REMARKS

In the Drawings:

FIG. 1

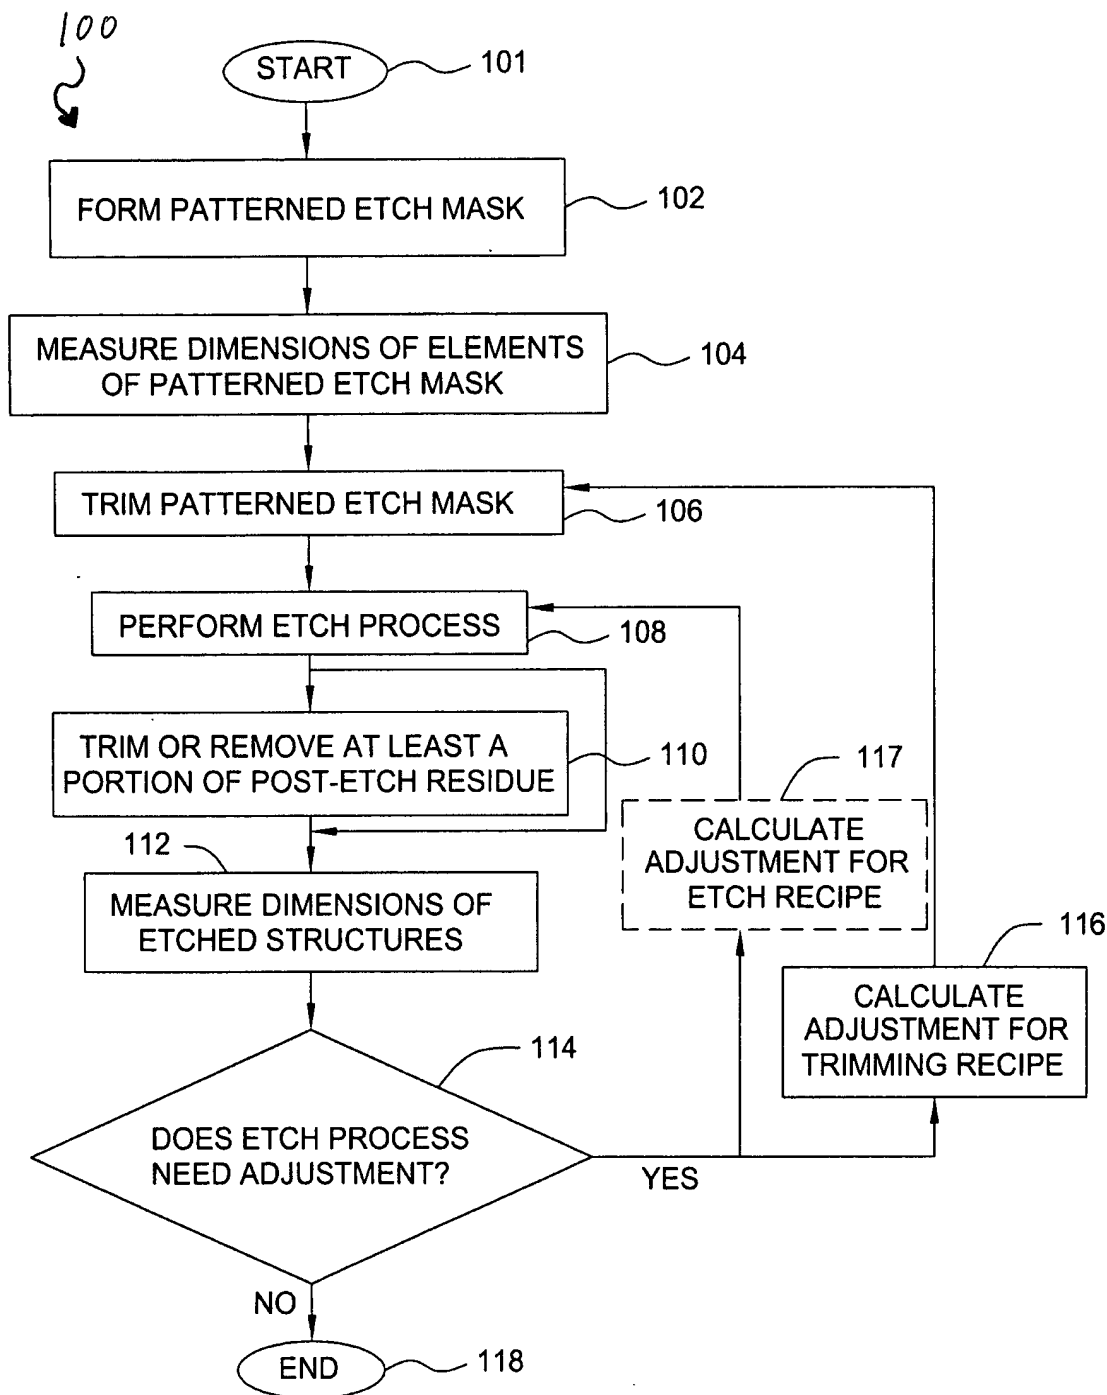
In Figure 1, previously omitted element label 100 has been inserted.
